ARCHITECTURAL REVIEW BOARD MEETING
CITY HALL, 385 SOUTH GOLIAD STREET, ROCKWALL, TEXAS
AUGUST 26, 2025 IN THE CITY COUNCIL CONFERENCE ROOM AT 5:00 PM

PROJECT COMMENTS

PROJECT NUMBER: SP2025-033
PROJECT NAME: Site Plan for 102 West Bourn Street
SITE ADDRESS/LOCATIONS: 102 West Bourn Street, Rockwall, TX, 75087

08/21/2025: SP2025-033: Site Plan for 906 S Goliad

FLOOR PLAN

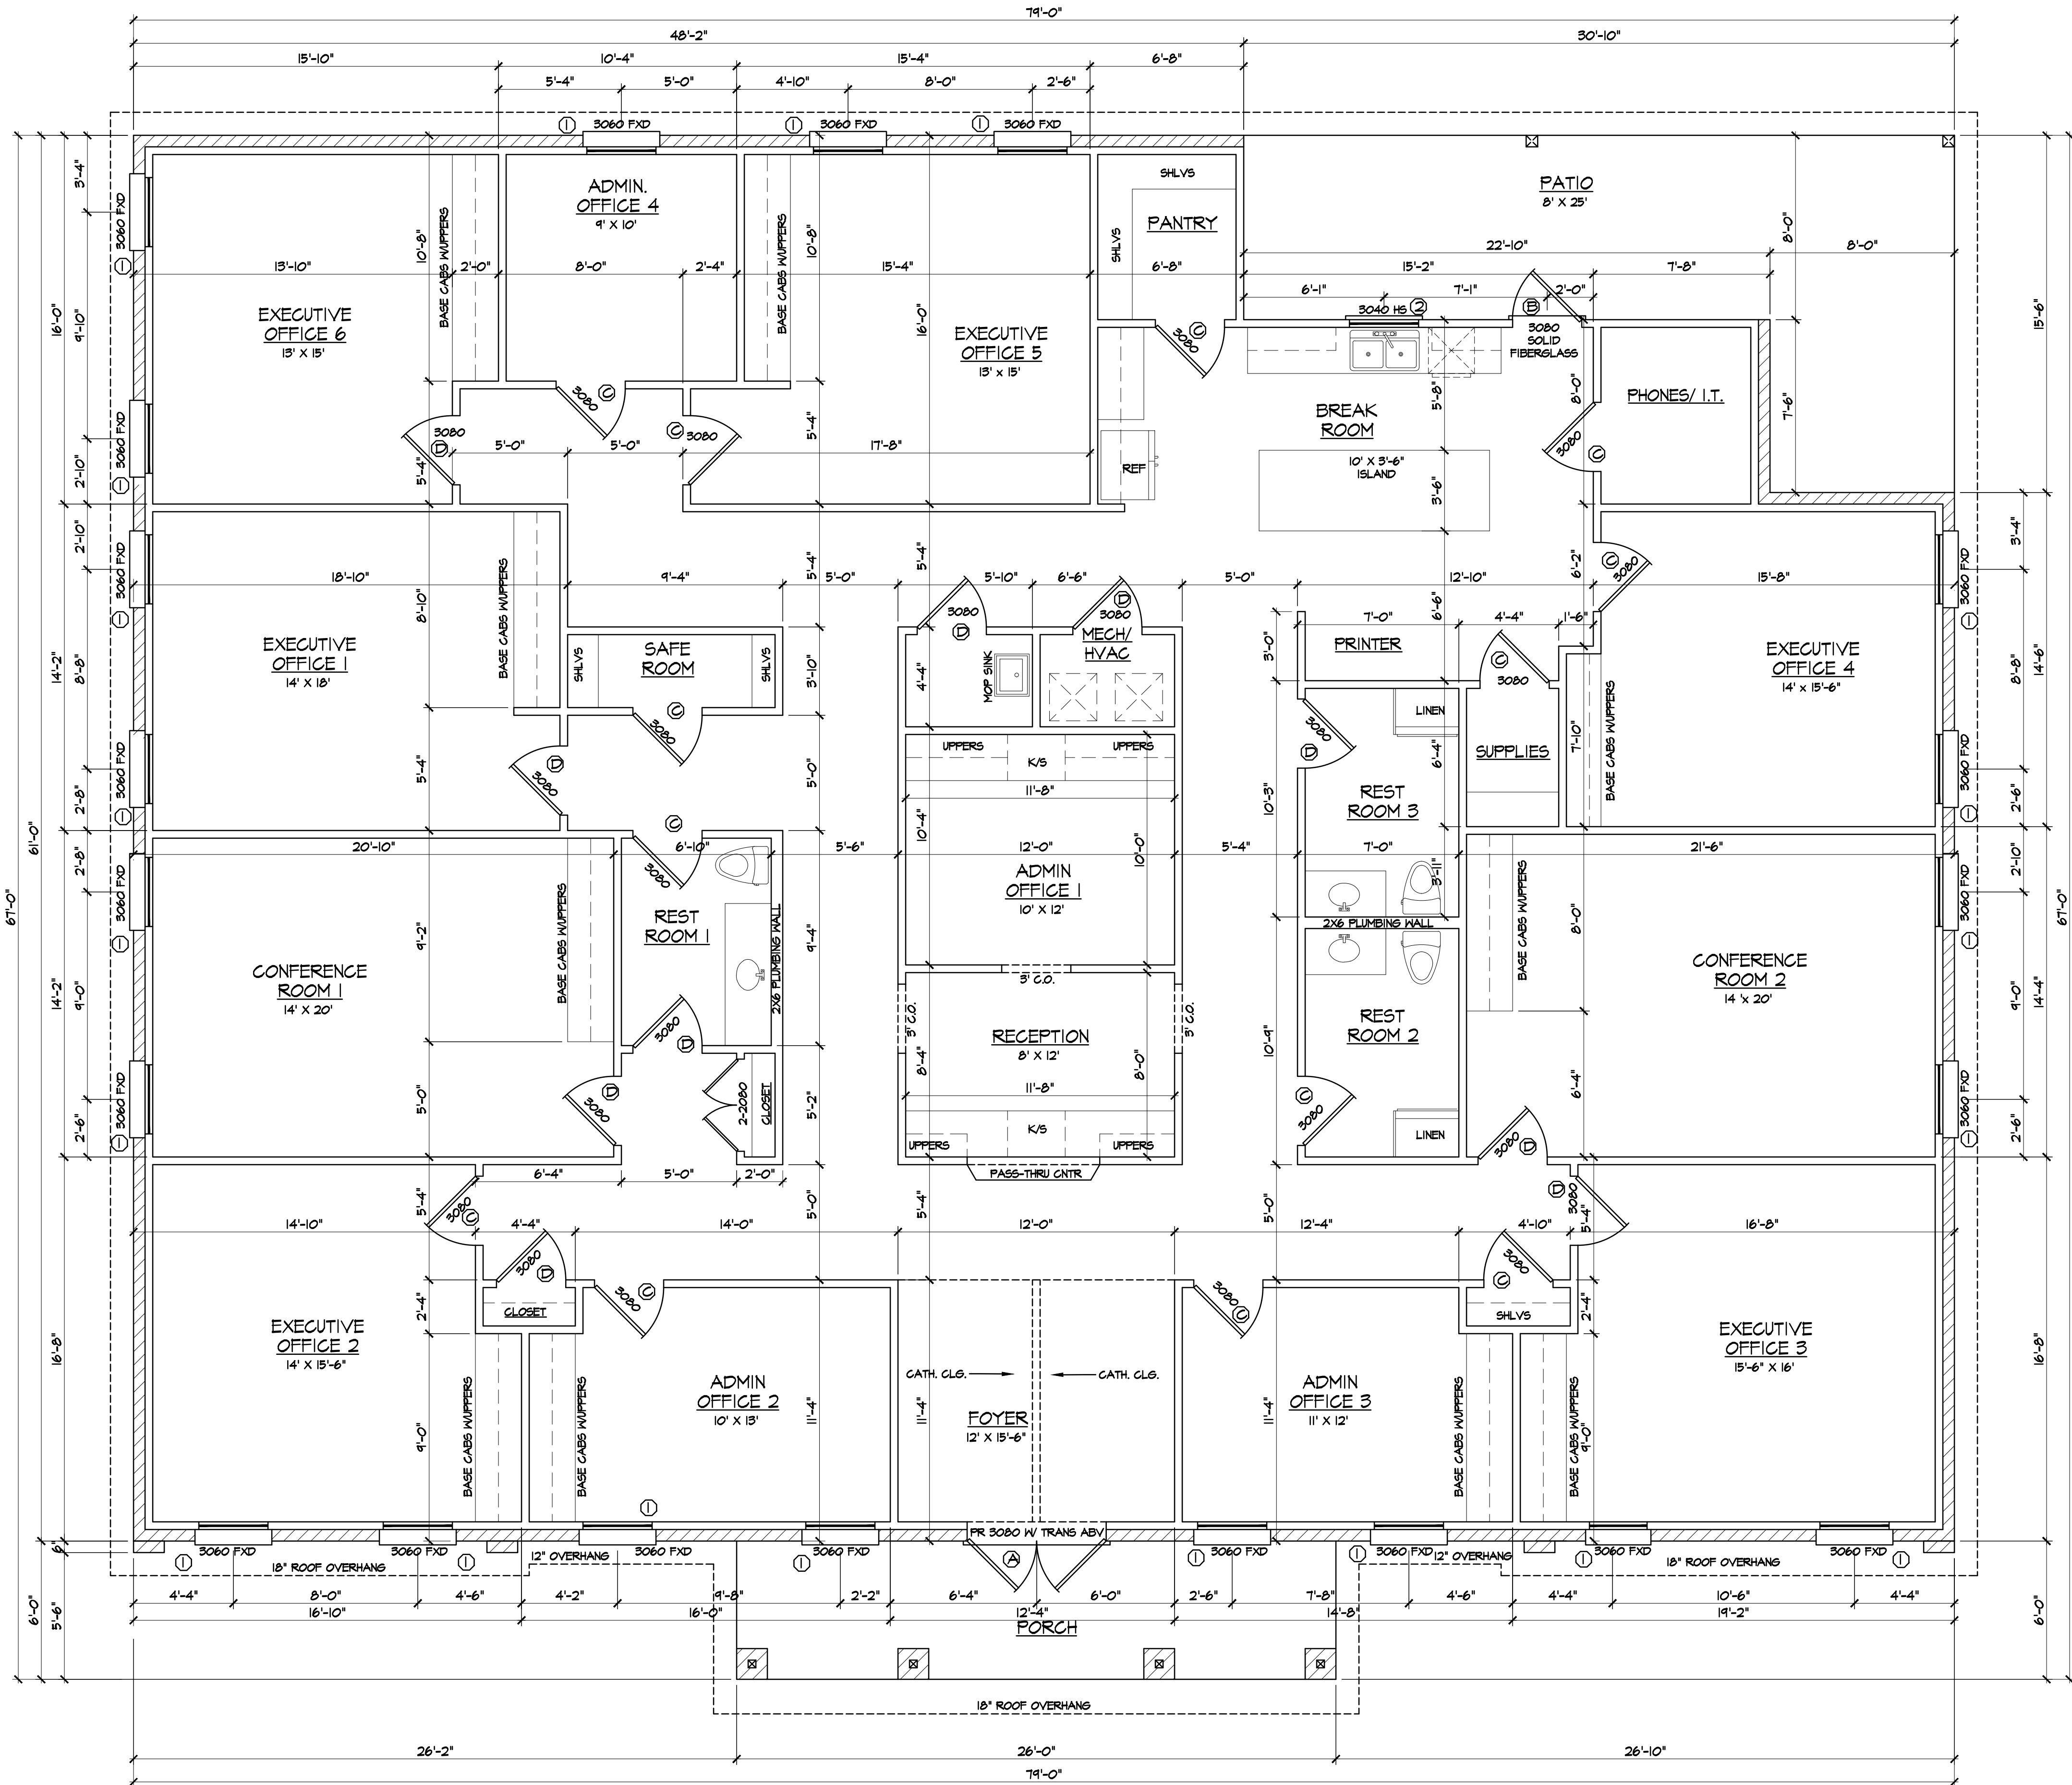
DEPARTMENT	REVIEWER	DATE OF REVIEW	STATUS OF PROJECT
BUILDING	Craig Foshee	08/21/2025	Approved
08/21/2025: DOES NOT APPROVE THE INTERIOR PLAN
